# Tamworth Solar Farm

Response to Request for  
Information September 2020

Prepared for: Tamworth Solar Farm Pty Ltd  
September 2020

■ Figure 1 Revised substation and BESS location showing bund

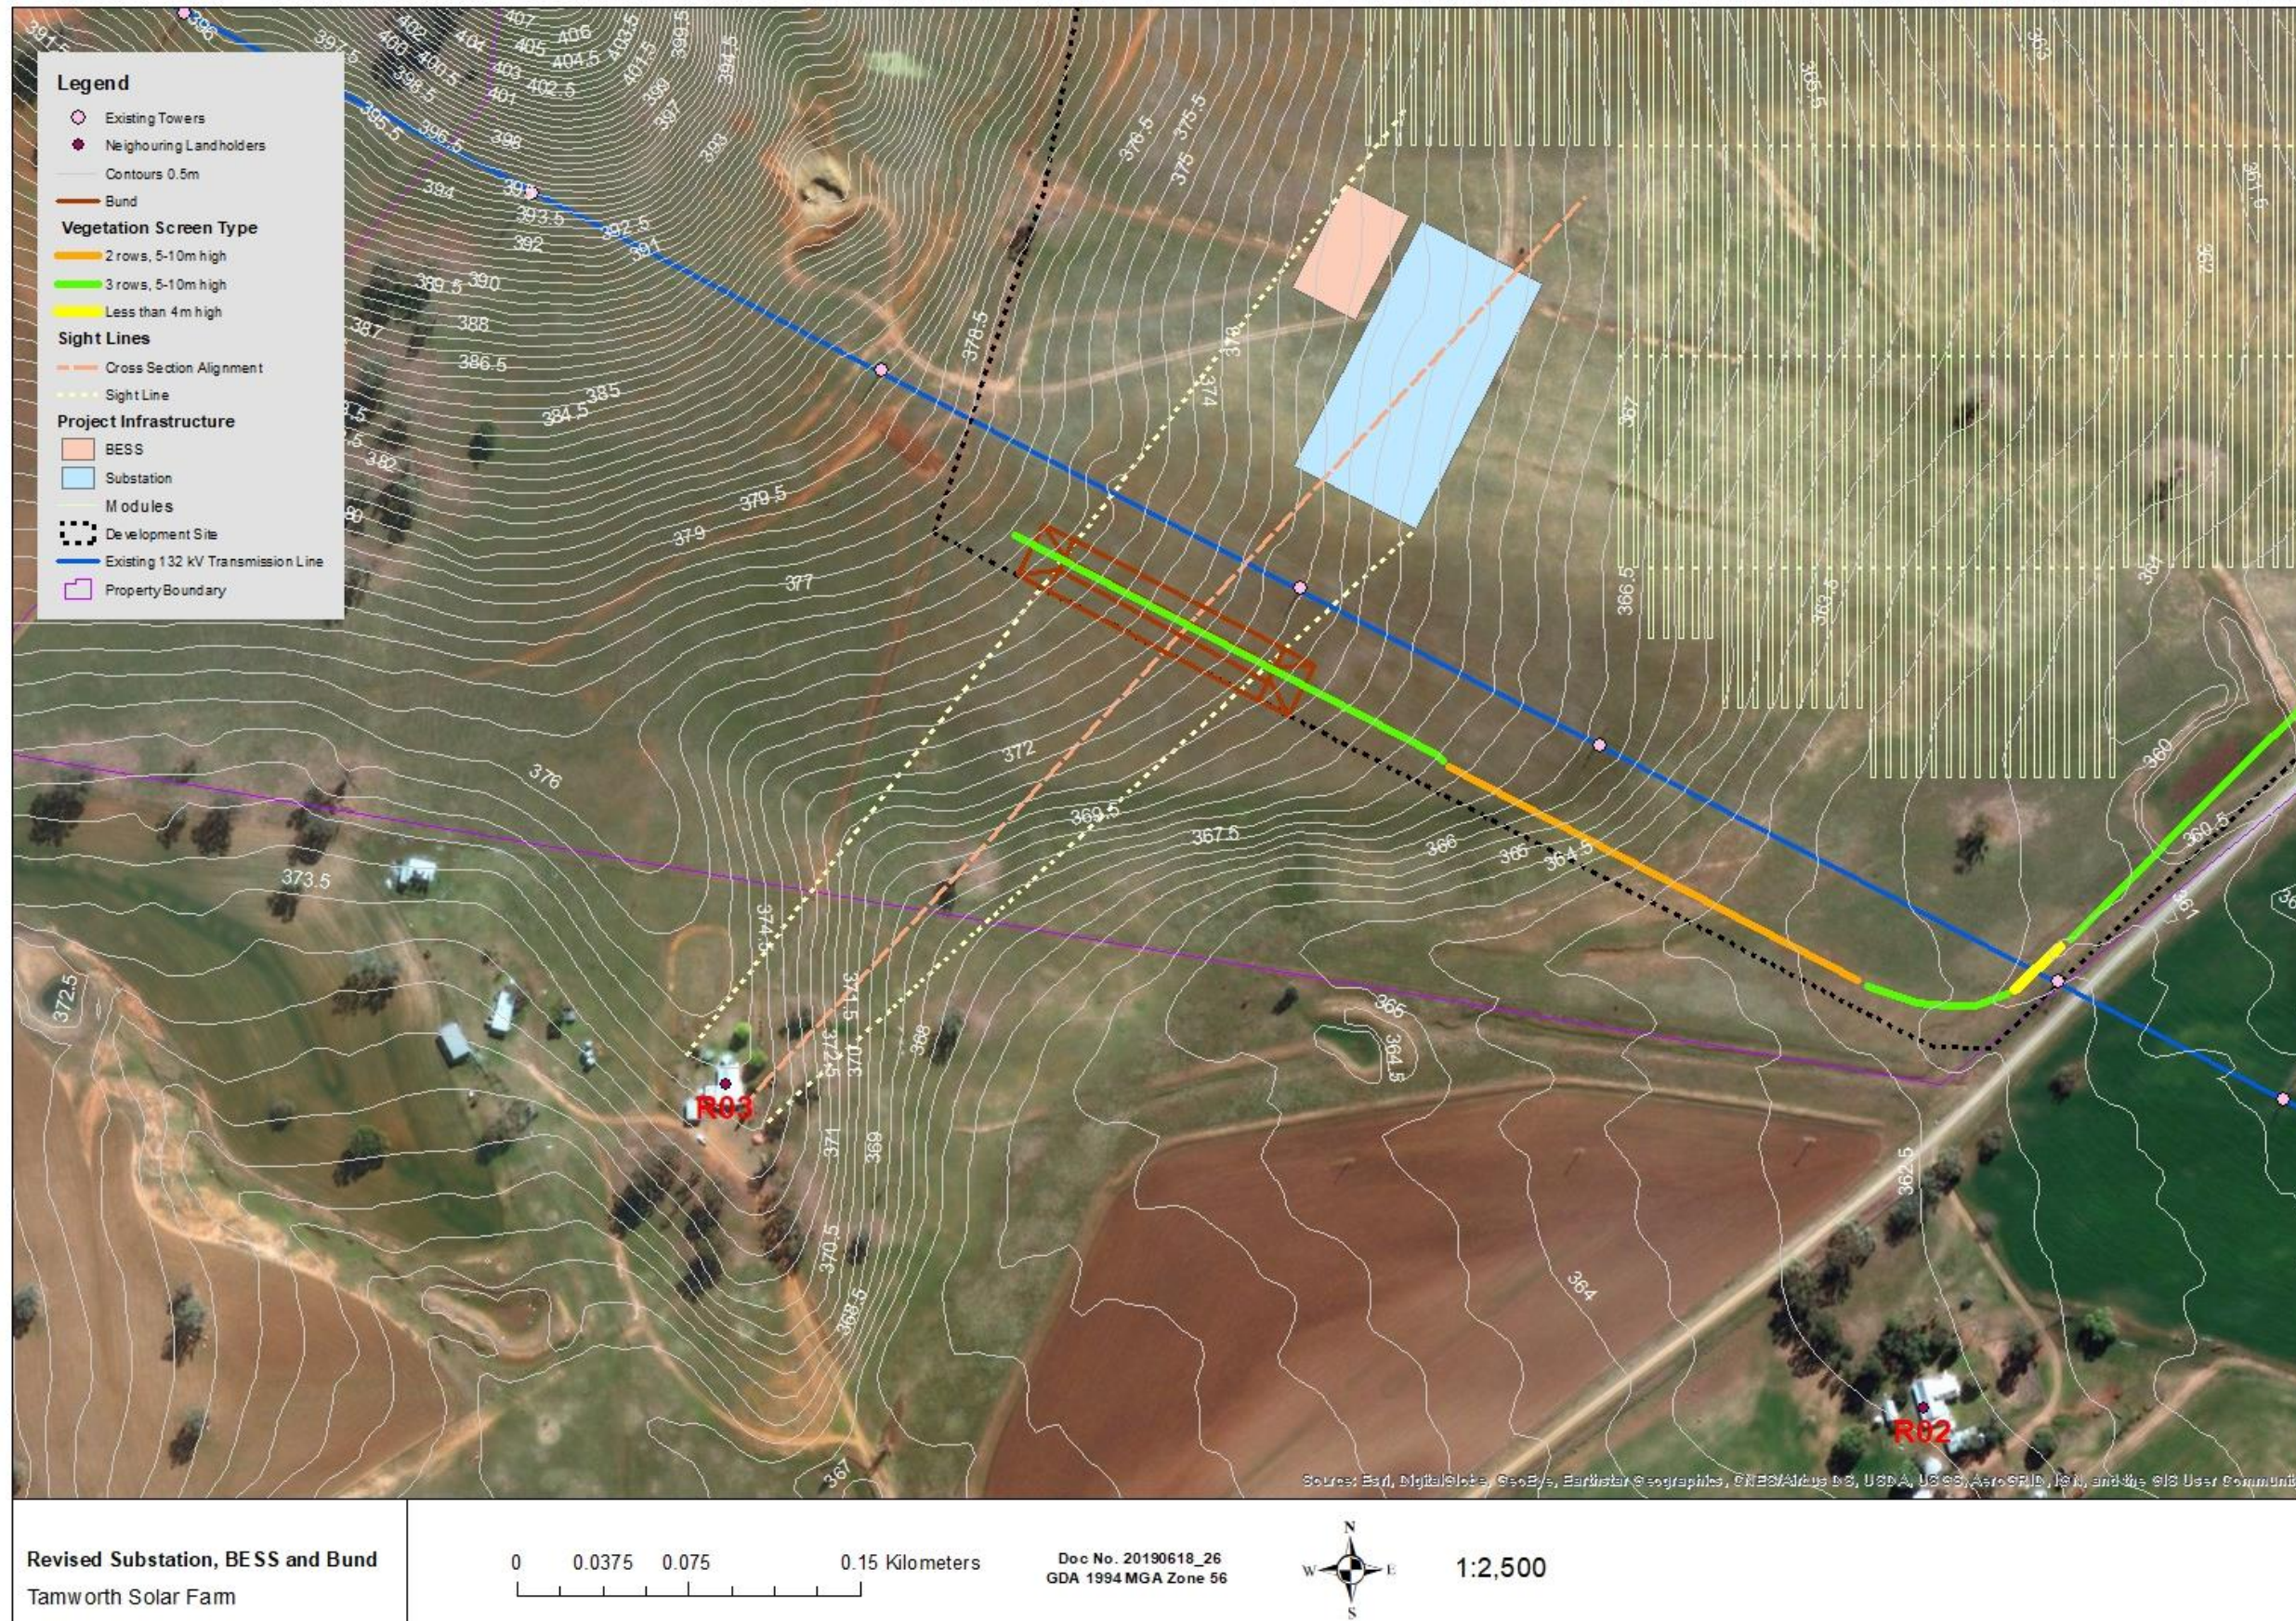
The Department of Planning, Industry and Environment (DPIE) have requested that Tamworth Solar Farm provide further consideration of measures to minimise visual impacts of the substation on the closest residential receivers including:

- whether alternate locations within the project site for the substation are reasonable and feasible; and
- further detail on the consideration of the mitigation measures and their effectiveness to reduce visual impact.

- Since the preparation of the initial visual impact assessment, the substation has been sited such that the long axis of the substation is perpendicular to the existing transmission line. This change reduces the width of the substation as seen from Residence R03.

- The BESS has been realigned such that the long axis of the BESS is now also perpendicular to the existing transmission line. In this position, the BESS is screened from R03 by the bund to be erected. The location of the infrastructure is shown in Figure 1.

- The size of the bund in commitment V9 of the EIS has been estimated following further assessment of the groundworks required for the substation. The bund will be approximately 3m high and 103m long, dependant on the final substation groundworks required. The batters on the side will be 1 in 3 (18 degrees slope) and the batters at either end will

be 1 in 5 (11 degrees slope). The width of the flat area at the top shall be approximately 7m. The bund has been placed inside the development site on the southern side of the transmission line to screen the view of the substation from R03. The location of the bund is shown in Figure 1. The bund will not infringe on the easement of the TransGrid transmission line. The bund runs directly down the slope and will therefore not adversely impact the flow of water across the site. Vegetation will be planted on the bund to increase the height of the visual screen. This will consist of three rows of vegetation that will grow to a height of 5 to 10m plus some lower growing species and ground covers to stabilise the bund and to help it blend it into the landscape. This bund and cutting the substation pad into the terrain were not taken into account in the original visual impact assessment.
